*Comment Received From: ConSol on behalf of Taylor Morrison
Submitted On: 6/17/2021
Docket Number: 21-BSTD-01*

Taylor Morrison - comment on requirements for duct insulation in conditioned space

Re: Docket Number 21-BSTD-01 2022 Energy Code Update Rulemaking

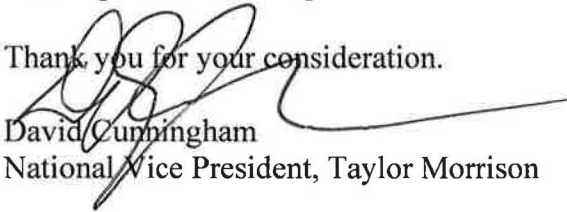
We are therefore disappointed to see that the Express Terms include language that would reduce our options for conditioned air distribution by effectively banning the use of uninsulated ducts in conditioned space. Section 150.0(m)1B, covering duct insulation requirements, would only allow uninsulated ducts in fully exposed locations, which is not a realistic option for obvious aesthetic reasons. The realistic option for uninsulated ductwork is for it to be run in cavities within the building thermal envelope. This currently requires insulation of R-4.2, which is reduced to R-3 or R-1 in the Express Terms. While this reduction will potentially reduce the cost of ducts run in conditioned space, the requirement for these ducts to be insulated at all is, we believe, unnecessary and unduly burdensome.

There is no requirement for insulation on ducts in conditioned space in either the IRC or the IECC, and no US state requires ducts in conditioned space to be insulated. As a national builder, Taylor Morrison, the need to change designs for the California market will impact our overall costs and our ability to deliver efficient houses to California customers.

While Taylor Morrison, we understand the Commissions caution regarding potential condensation issues, we have used uninsulated ducts in houses in climates with higher humidity levels than California, Washington, Oregon, Arizona, Nevada, Texas, Georgia, North Carolina, South Carolina and Florida and have not had any problems related to condensation. Based on this experience, we are confident that uninsulated ducts can be used in California without issue.

We recommend that rather than further limiting the use of uninsulated ducts, the language in the Express Terms should be amended to allow the unrestricted use of uninsulated ducts in the building’s conditioned space. This can be simply achieved by amending Section 150.0(m)1B to read:

“Portions of supply-air and return-air ducts and plenums of a space heating or cooling system outside of the buildings conditioned space shall be insulated to a minimum installed level of R-6.0”
